REPORT OF ALTERATIONS TO DESIGNATED RESOURCE

Site Number/Address: 503 Mathews Street

Laurel School National Register Historic District

Roof repair report

1

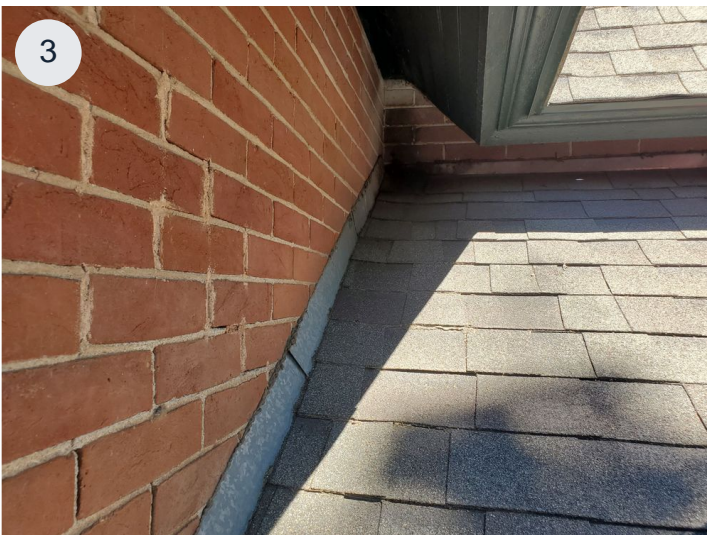
Chimney cap metal is rusted through, repairs not possible. Recommend replacement.

3

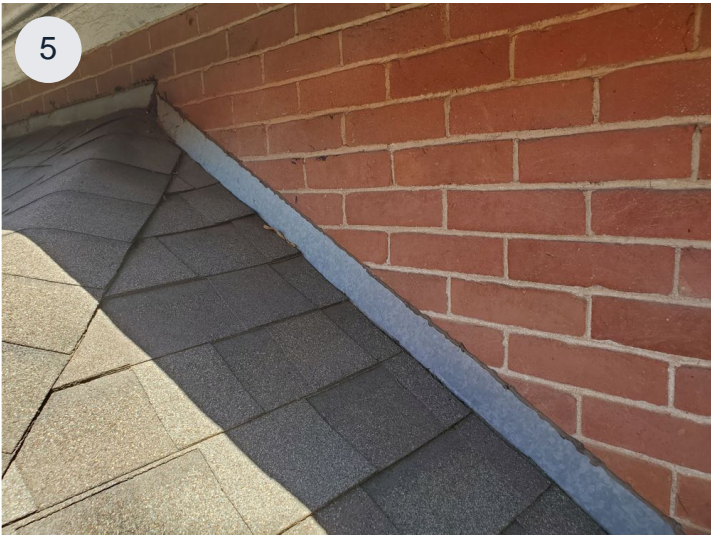
Missing counter flashing at wall

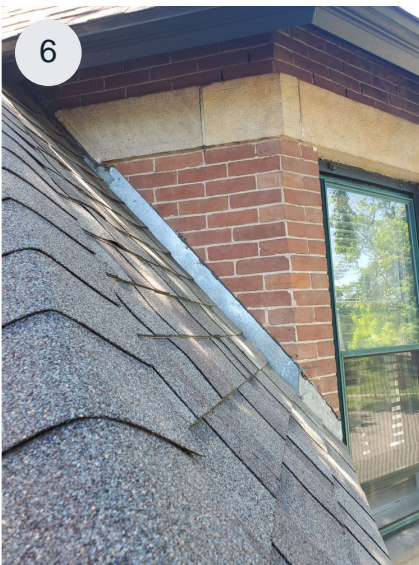
5 Missing step and counter flashing

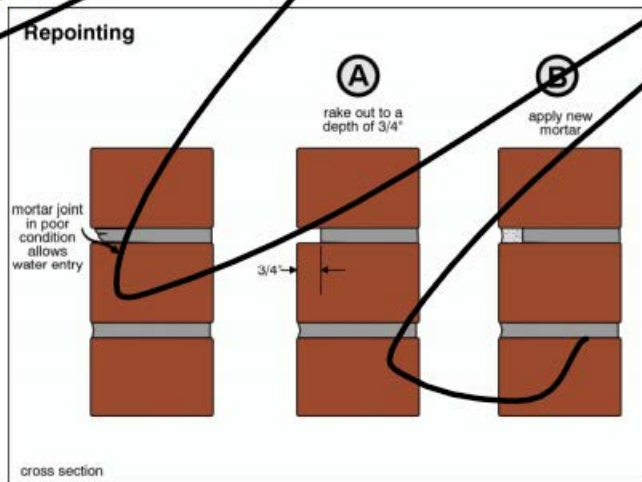
WALLS \ Masonry (brick, stone) and concrete**6. Condition:** • **Mortar deterioration**

Exterior walls had many areas of mortar joint deterioration at time of inspection. These areas should be re-pointed to prevent continued deterioration from freezing moisture. The Inspector recommends you consult with a qualified contractor to discuss options and costs for re-pointing using Portland Cement.

Implication(s): Chance of water entering building | Weakened structure | Chance of structural movement
